Well Name: NOW I WON 25-24
FEDERAL COM

Well Number: 4H

Type of Action: APD Change

New Well Name: OLIVE WON UNIT 104H

C-102 Submit Electronically Via OCD Permitting	State of New Mexico Energy, Minerals, & Natural Resources Department OIL CONSERVATION DIVISION	Revised July 9, 2024 PAGE 1 OF 2
		Submittal Type: ☐ Initial Submittal ☒ Amended Report ☐ As Drilled

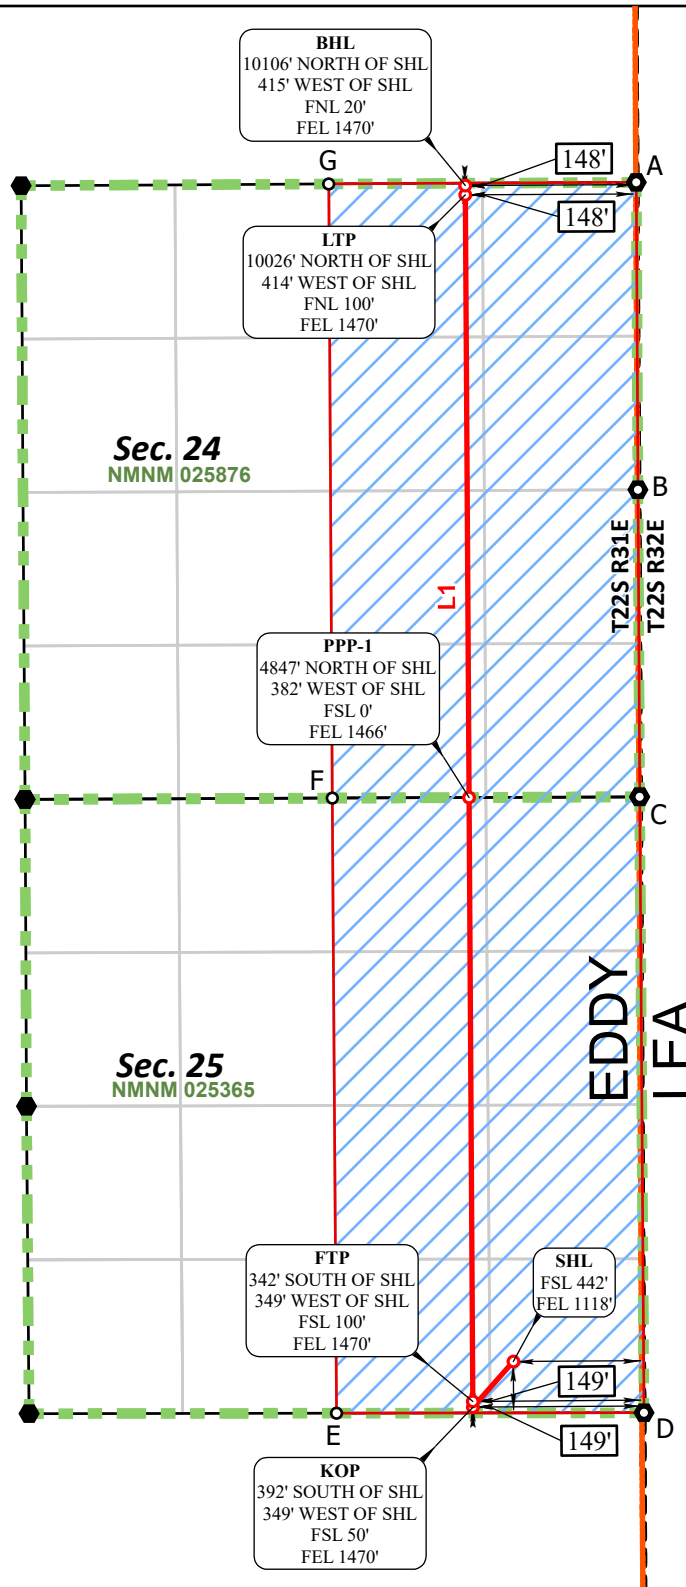
Old SHL: 442' FSL 1178' FEL

New SHL: 442' FSL 1118' FEL

Old BHL: 20' FNL 420' FEL

New BHL: 20' FNL 1470' FEL

Old HSU: 320 acres

New HSU: 640 acres
